Access Compliance Report

Public Rights-of-Way

Intersection ID: 14278	Main Street: ROMARE_BEARDEN_DR	Cross Street: FARMER_ST	Location: NE
ADA ID: F0D2C7172217	Ramp Type: Perp	Initial Pass/Fail: Fail	Overall Compliance: No
		Severity Score: 12.5

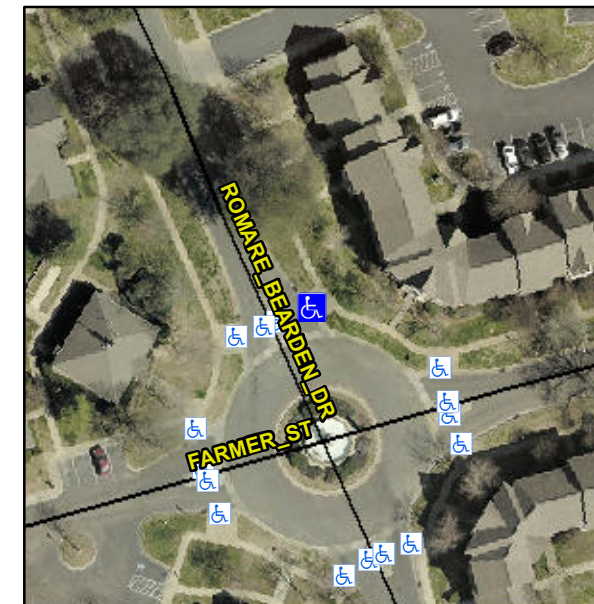
Not Found, R304.2.2

Compliance	Description	Data	Compliance	Description	Data
N/A	Ramp Length (in)	94.5	No	Ramp Slope (%)	9.8
Yes	Ramp Width (in)	50.0	Yes	Ramp XSlope (%)	0.7
N/A	Flare Type LT	N/A	N/A	Flare Type RT	N/A
N/A	Flare Slope LT (%)	N/A	N/A	Flare Slope RT (%)	N/A
N/A	Flare Traversable LT?	N/A	N/A	Flare Traversable RT?	N/A
N/A	Landing Length (in)	N/A	N/A	DWS Provided?	N/A
N/A	Landing Width (in)	N/A	N/A	DWS Contrast?	N/A
N/A	Landing Slope (%)	N/A	N/A	DWS Length (in)	N/A
N/A	Landing X Slope (%)	N/A	N/A	DWS Full Width?	N/A
N/A	Landing Curb? (Y/N)	N/A	N/A	DWS Offset (in)	N/A
N/A	Shared Landing?	N/A			
N/A	Gutter Ponding?	N/A	N/A	Gutter Slope (%)	N/A
N/A	Gutter Lip Ht (in)	N/A	N/A	Gutter X Slope (%)	N/A
N/A	Painted X Walk1?	No	N/A	Painted X Walk2?	N/A
	X Walk 1 Direction	To W		X Walk 2 Direction	N/A
N/A	X Walk 1 Width (in)	N/A	N/A	X Walk 2 Width (in)	N/A
	X Walk 1 Slope (%)	1.4		X Walk 2 Slope (%)	N/A
	X Walk 1 X Slope (%)	1.9		X Walk 2 X Slope (%)	N/A

Remove & Replace Entire Ramp.
